**EAST GOSHEN TOWNSHIP
PLANNING COMMISSION
Meeting Agenda
Tuesday, September 24, 2024
7:00 PM**

Date: September 18, 2024
To: East Goshen Township Planning Commission
From: Kelly A. Krause, Zoning Officer
Re: **1365/1373 Enterprise Drive**
Communications Test Design, Inc & Parsons 1365, LLC
Preliminary Land Development Plan

Re: East Goshen Township – Application of Communications Test Design, Inc. -
Preliminary Land Development Plans for One CTDI Place, dated April 29, 2024

**RE: PRELIMINARY LAND DEVELOPMENT PLANS (REVISED)
COMMUNICATIONS TEST DESIGN, INC. (CTDI)
1373 ENTERPRISE DRIVE, WEST CHESTER, PA 19380
EAST GOSHEN TOWNSHIP, CHESTER COUNTY, PA
CVE PROJECT # 22024-1000
PENNONI # EGOST 00142**

SITE PLAN

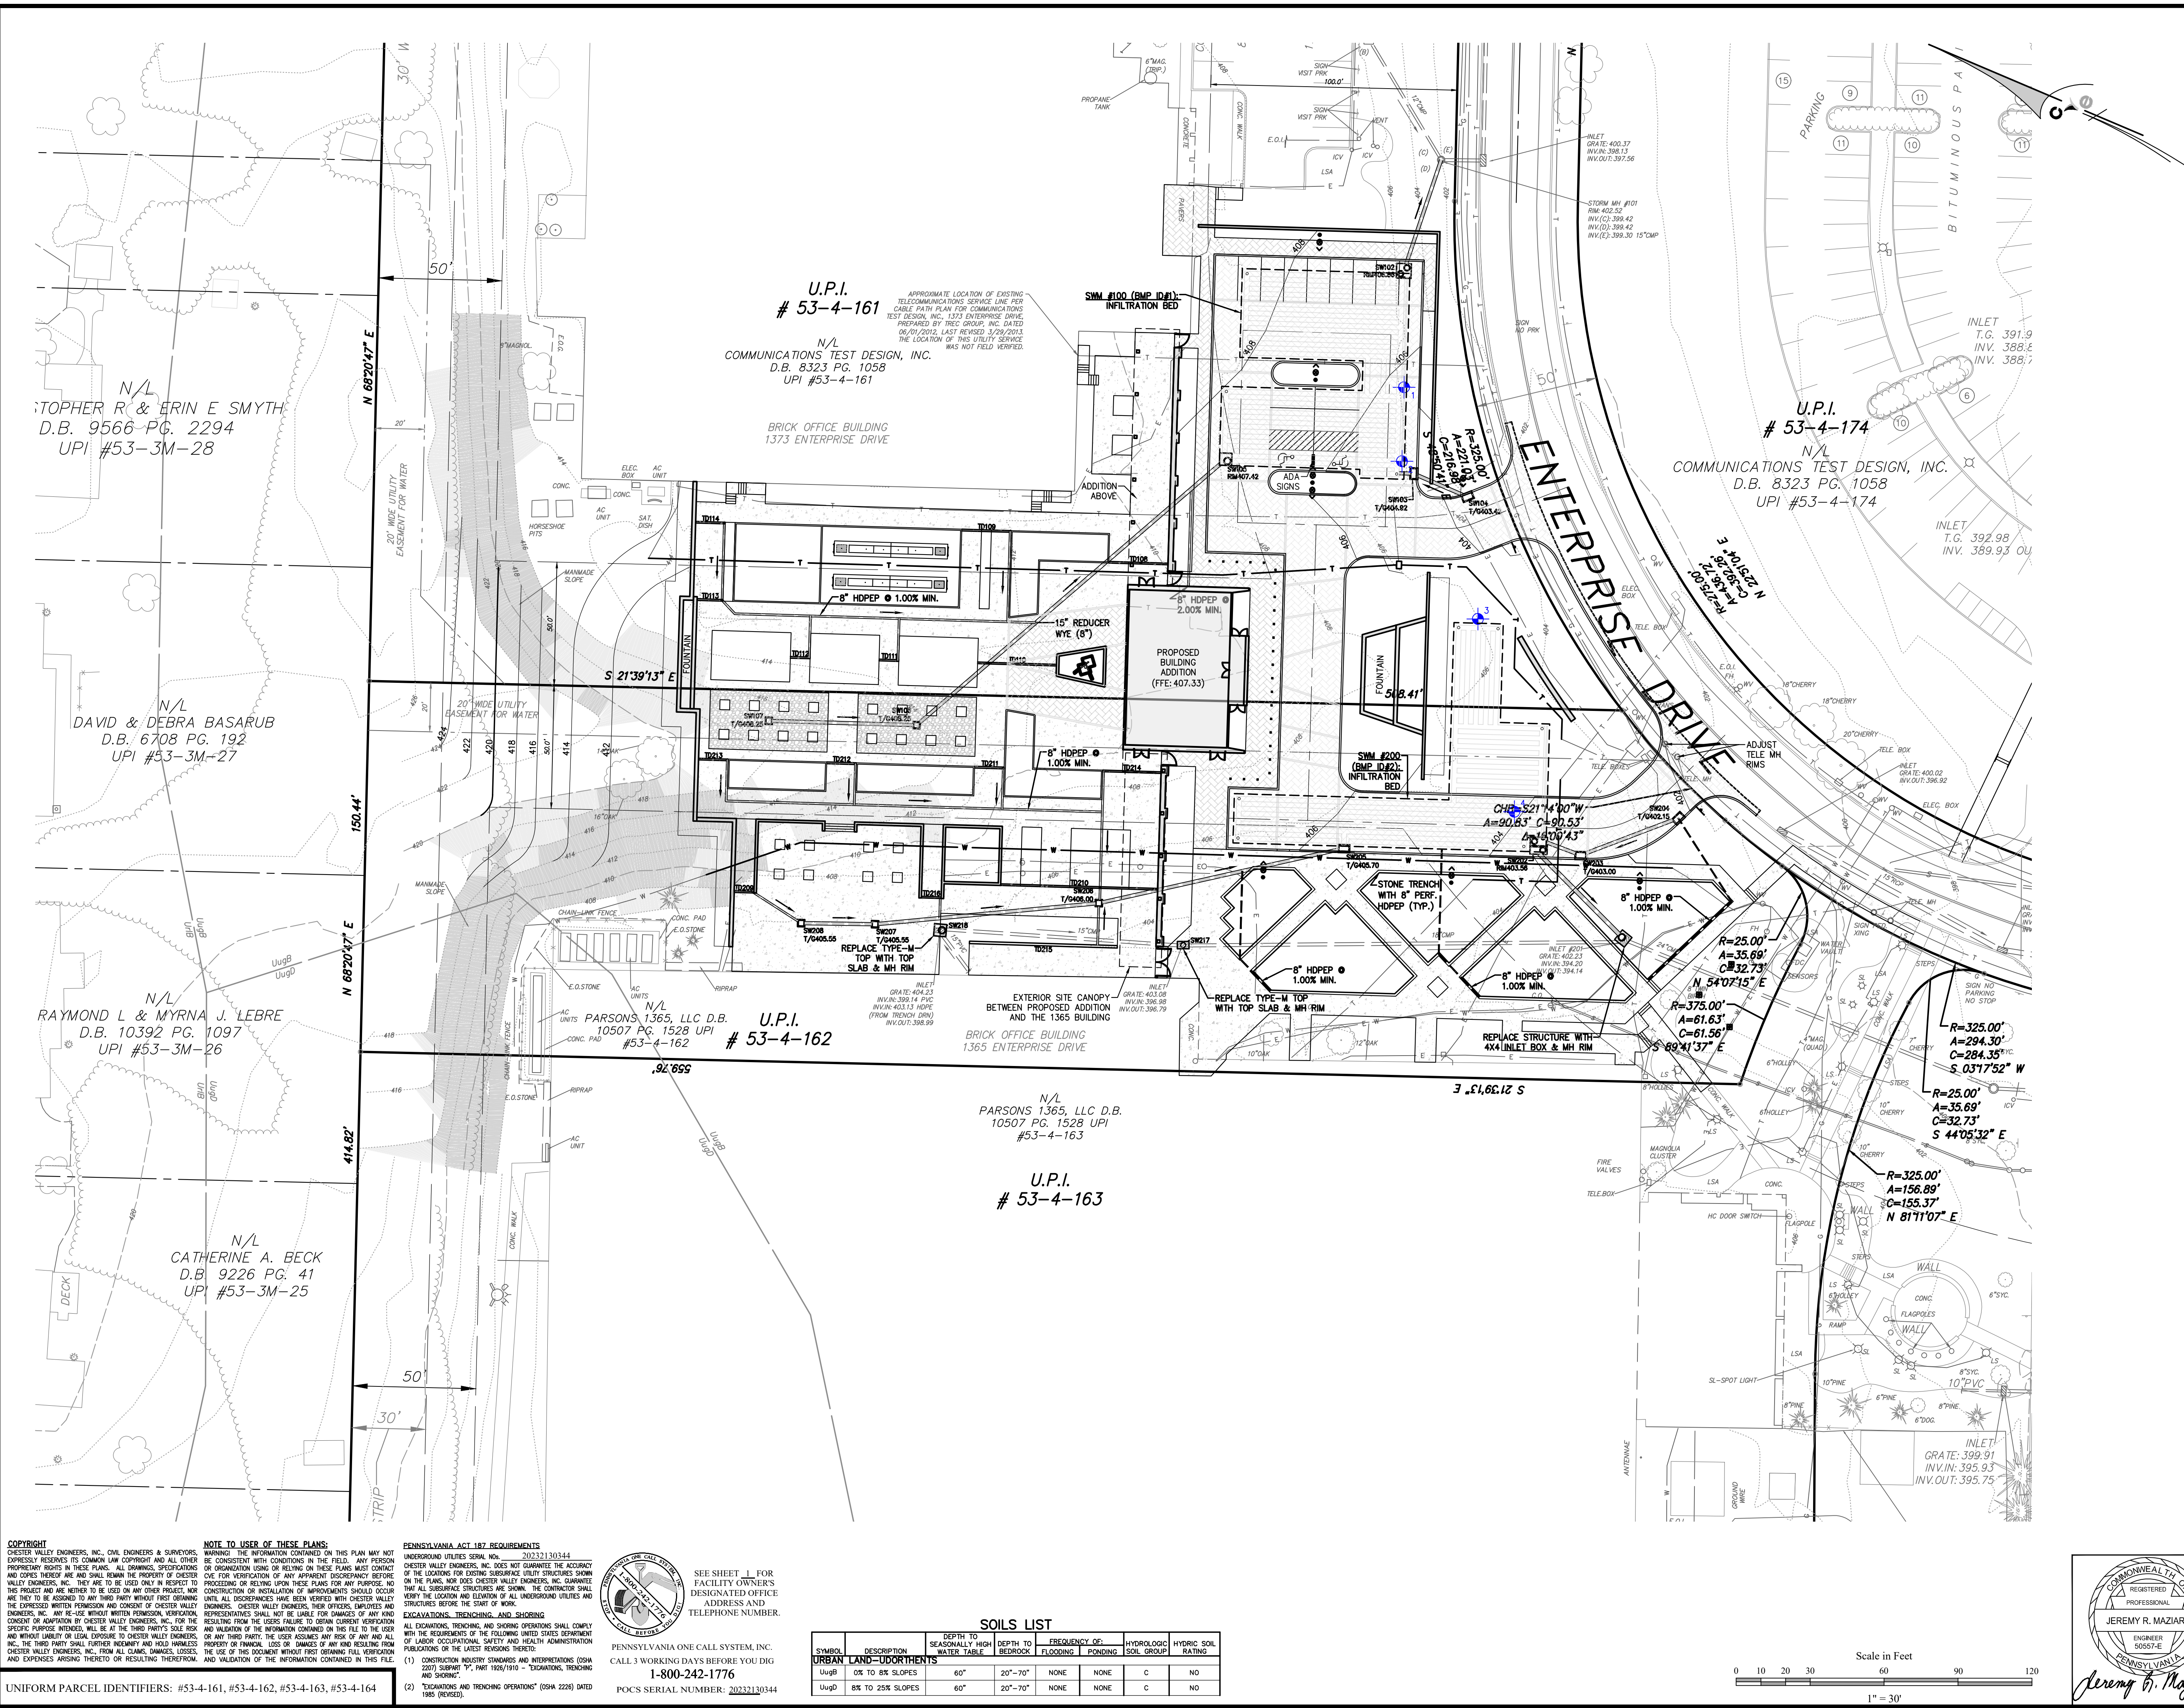
3. Minimum side yard setbacks shall be 50 feet. (§240-21.G) While the proposed building is located on the common property line, it appears the proposed condominium between the parcels negates the side yard setback requirement. Defer to Township Solicitor.
CVE Response: We agree that the proposed condominium negates the side yard setback requirement.

4. Minimum front yard setbacks shall be 100 feet. (§240-21.G) The proposed fountain is within the 100 yard front yard setback. Further discussion may be required regarding this feature.
CVE Response: The proposed fountain is essentially a relocation of the existing fountain in front of the 1373 building to a new location in front of the proposed building addition. The existing fountain is currently located within the front yard setback and is being replaced with a proposed parking and driveway connection to Enterprise Drive. The relocated fountain will continue the existing legal non-

13. A minimum clear sight triangle of 75 feet (as measured from the center-line intersections of two streets) shall be provided at all intersections. (§205-49.A) Clear sight triangles should be added to the plans.

CVE Response: Clear sight triangles have been added to the plan set.
